**PLANS AND DOCUMENTS
referred to in the PDA
DEVELOPMENT APPROVAL**

Approval no: DEV2019/1074

Addendum to radiant heat exposure modelling - Carseldine Urban Village – 532 Beams Road, Carseldine, Queensland.

Client Economic Development Queensland		Project Carseldine Urban Village	
Design 5.12.2019	Land Environment Consultants	Title AS 3959-2018 BAL contours	FIGURE 1
Drawn 5.12.2019	Bentline MP		
Scale 1:4000			
Cad File LEC_Carseldine UV07.dwg	Rev 1.0

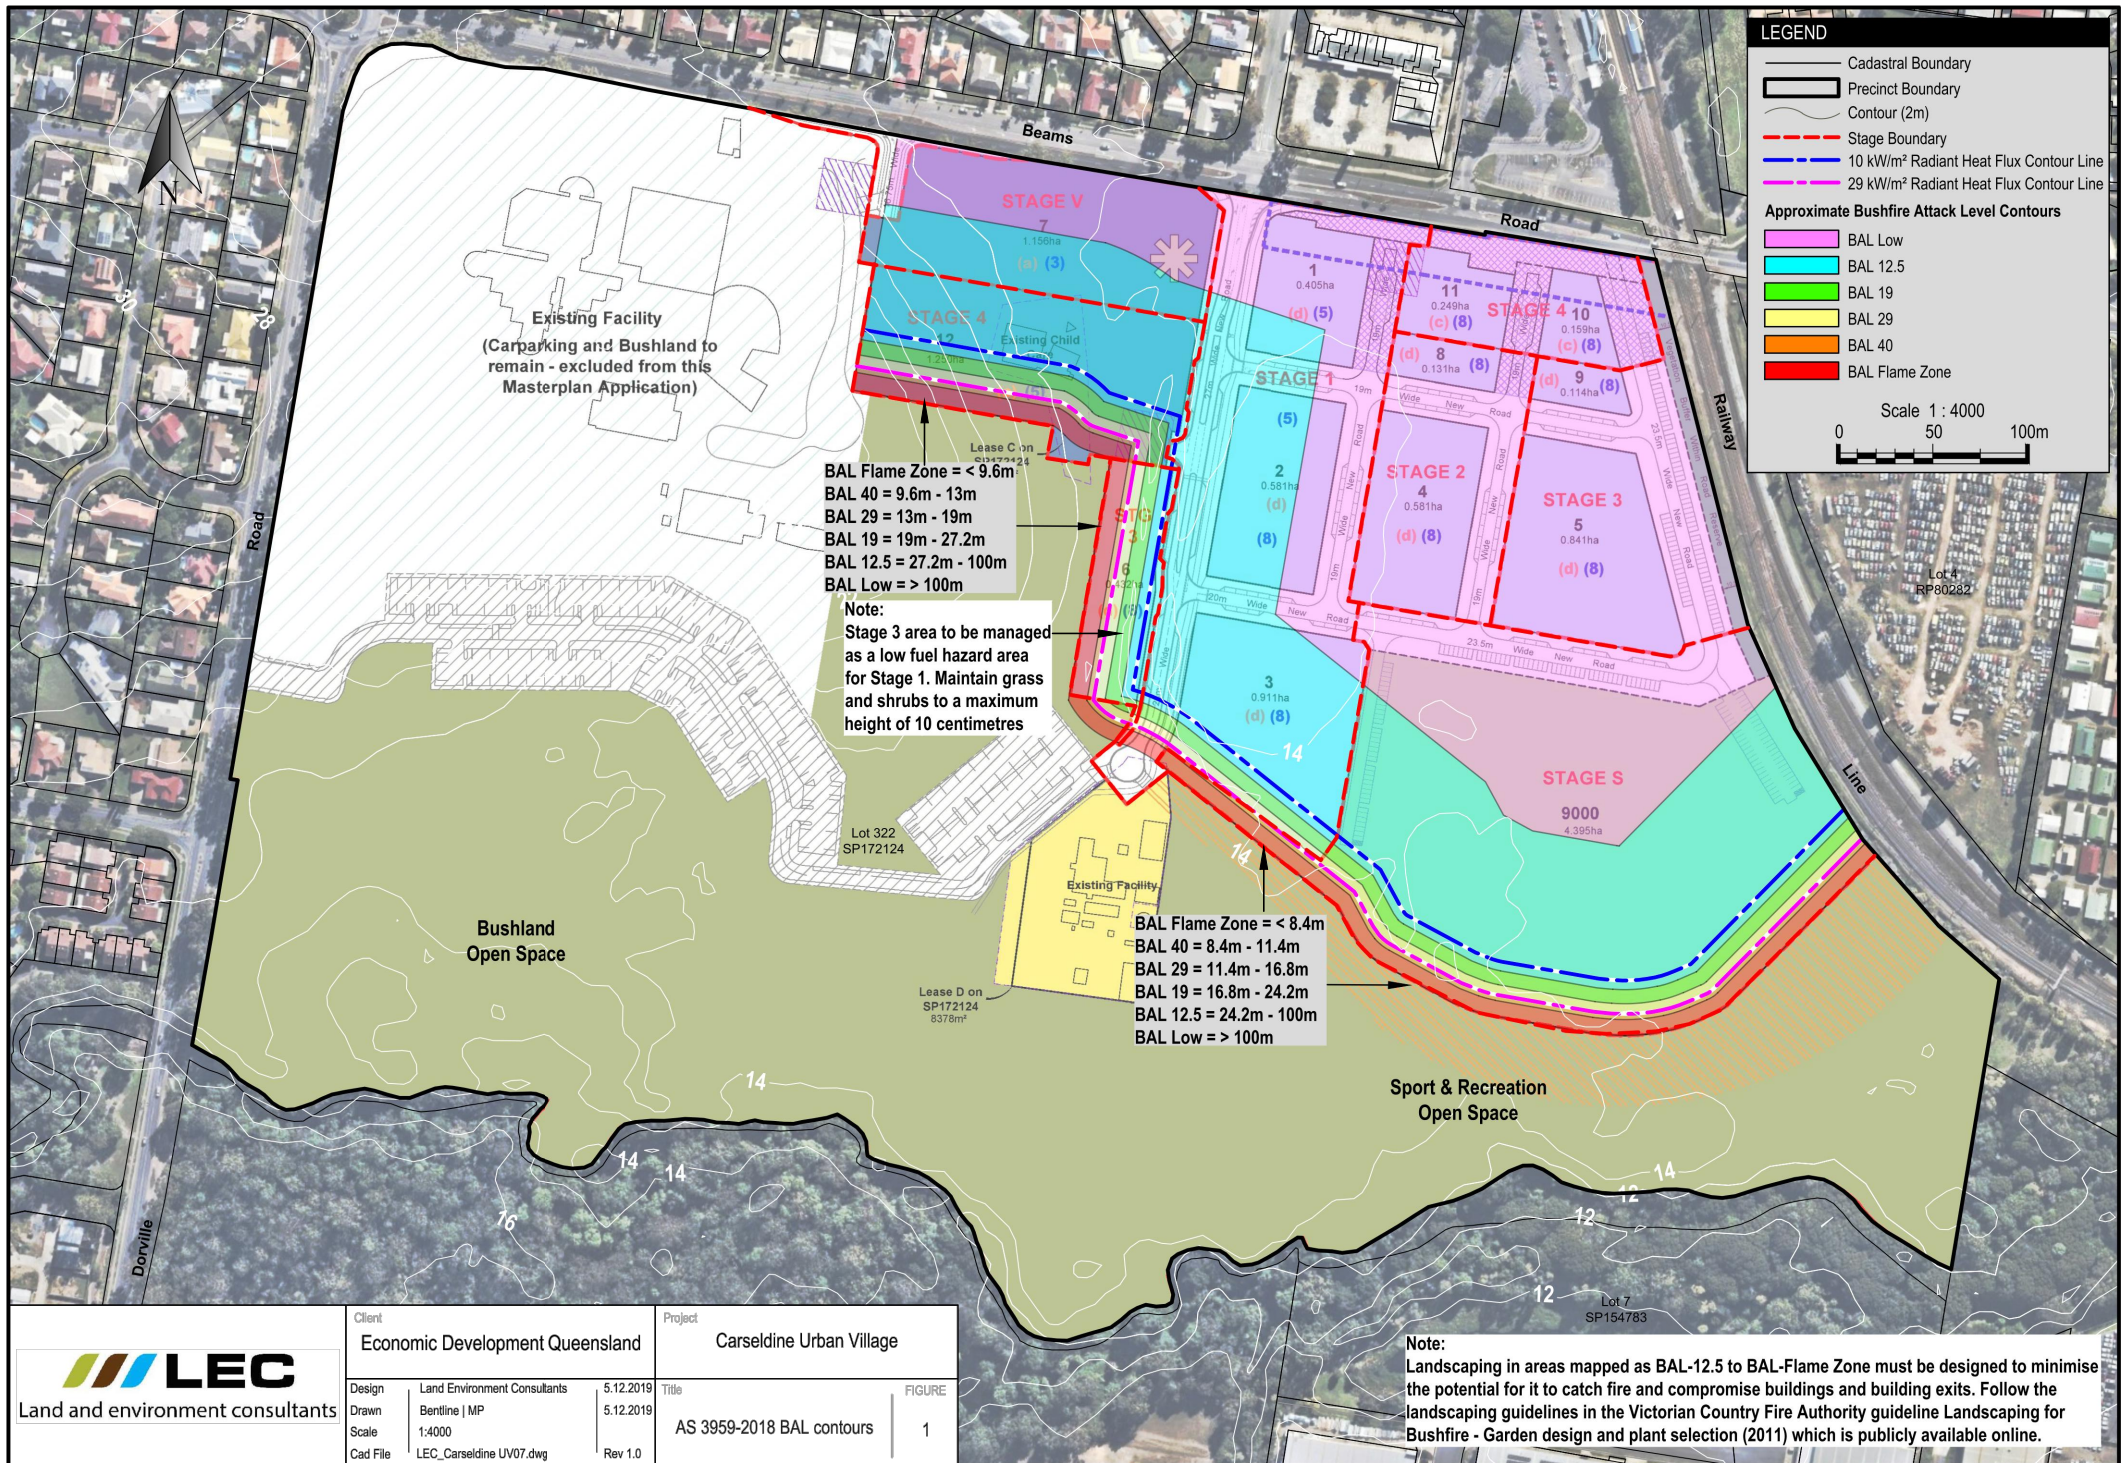
In 2019, LEC reviewed and revised assumptions and inputs used in the radiant heat exposure modelling in the bushfire management plan (LEC 2018) and prepared new bushfire attack level (**BAL**) contour plans for the proposed development which identify approximate BAL contours and the 10 kilowatt/square meter (**kW/m²**) and 29 kW/m² radiant heat flux contours from which asset protection zones were determined for 'vulnerable' use development and other development, respectively. The new BAL contour plans for the proposed development are provided at Appendix 1.

The revised radiant heat exposure modelling is consistent with technical guidelines and options for radiant heat exposure modelling by the Queensland Fire and Emergency Services (**QFES**) in *Bushfire Resilient Communities Technical Reference Guide for the State Planning Policy State Interest 'Natural Hazards, Risk and Resilience - Bushfire'* (QFES 2019) (**Bushfire resilient communities**). The exception is that LEC did not adopt the recommended input for flame temperature in Bushfire resilient communities, ie 1,200 kelvin (**K**), over the standard flame temperature input specified in the *Australian Standard for Construction of Buildings in Bushfire Prone Areas* (AS 3959-2018) for the 'method 2' BAL assessment procedure, which is 1,090 K.

The proposed development is infill development with a suburban context and is exposed to a relatively small and isolated bushfire hazard area as opposed to a large continuous bushfire hazard area associated with a wildland setting, eg Mt Coot-tha Forest Park which adjoins the D'Aguiar National Park, etc. Therefore, it was considered that a balanced approach was warranted when reviewing and revising the radiant heat exposure modelling in the bushfire management plan (LEC 2018) and the standard flame temperature input specified in AS 3959-2018 for the 'method 2' BAL assessment procedure was used, ie 1,090 K.

BAL Flame Zone = < 9.6m
BAL 40 = 9.6m - 13m
BAL 29 = 13m - 19m
BAL 19 = 19m - 27.2m
BAL 12.5 = 27.2m - 100m
BAL Low = > 100m

Note:
Stage 3 area to be managed as a low fuel hazard area for Stage 1. Maintain grass and shrubs to a maximum height of 10 centimetres

BAL Flame Zone = < 8.4m
BAL 40 = 8.4m - 11.4m
BAL 29 = 11.4m - 16.8m
BAL 19 = 16.8m - 24.2m
BAL 12.5 = 24.2m - 100m
BAL Low = > 100m
